Access Compliance Report

Public Rights-of-Way

(Curb Ramps)

Intersection ID: 10030167	Main Street: LATROBE_DR	Cross Street: N/A	Location:	N
ADA ID: 3900433EF0AA	Ramp Type: BlendTrans1	Initial Pass/Fail: Fail	Overall Compliance: No	Severity Score: 12.5

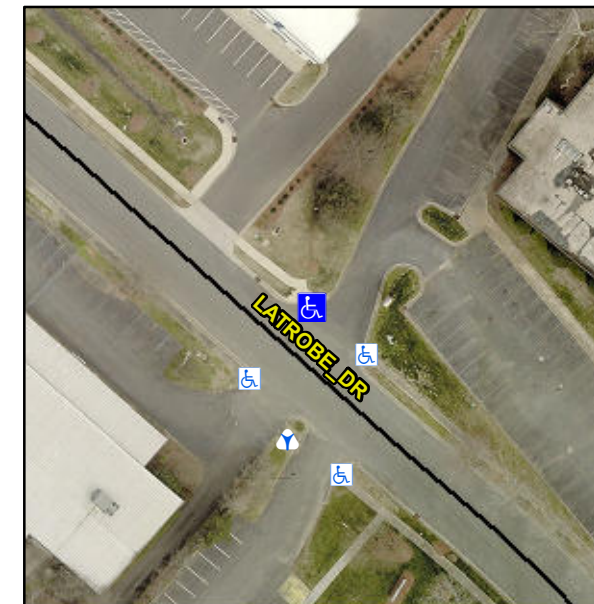
Not Found, R304.5.3

Compliance	Description	Data	Compliance	Description	Data
N/A	Ramp Length (in)	73.0	Yes	BlendTrans Slope (%)	0.8
Yes	Ramp Width (in)	61.0	No	BlendTrans XSlope (%)	5.8
N/A	Flare Type LT	N/A	N/A	Flare Type RT	N/A
N/A	Flare Slope LT (%)	N/A	N/A	Flare Slope RT (%)	N/A
N/A	Flare Traversable LT?	N/A	N/A	Flare Traversable RT?	N/A
N/A	Landing Length (in)	N/A	N/A	DWS Provided?	N/A
N/A	Landing Width (in)	N/A	N/A	DWS Contrast?	N/A
N/A	Landing Slope (%)	N/A	N/A	DWS Length (in)	N/A
N/A	Landing X Slope (%)	N/A	N/A	DWS Full Width?	N/A
N/A	Landing Curb? (Y/N)	N/A	N/A	DWS Offset (in)	N/A
N/A	Shared Landing?	N/A			
N/A	Gutter Ponding?	N/A	N/A	Gutter Slope (%)	N/A
N/A	Gutter Lip Ht (in)	N/A	N/A	Gutter X Slope (%)	N/A
N/A	Painted X Walk1?	No	N/A	Painted X Walk2?	No
	X Walk 1 Direction	To SW		X Walk 2 Direction	To SE
	X Walk 1 Width (in)	N/A		X Walk 2 Width (in)	N/A
	X Walk 1 Slope (%)	0.8		X Walk 2 Slope (%)	2.0
	X Walk 1 X Slope (%)	3.1		X Walk 2 X Slope (%)	5.4

N/A	Ramp inside XWalk1?	N/A	N/A	Ramp inside XWalk2?	N/A
	Road Slope (%)	4.2		Clear Space?	N/A
	Road X Slope (%)	0.6	N/A	Clear Space to XWalk (in)	N/A
N/A	Any Obstructions?	N/A	N/A	Storm Grate/Utility Hazard?	N/A
	Obstruction Type			Storm Grate/Utility Type	
		N/A			N/A
			Yes	Surface Condition? (G/P)	Good
			No	Curb Slope (%)	6.8

Remove & Replace Curb Ramp With Two New Directional Ramps or Equivalent.
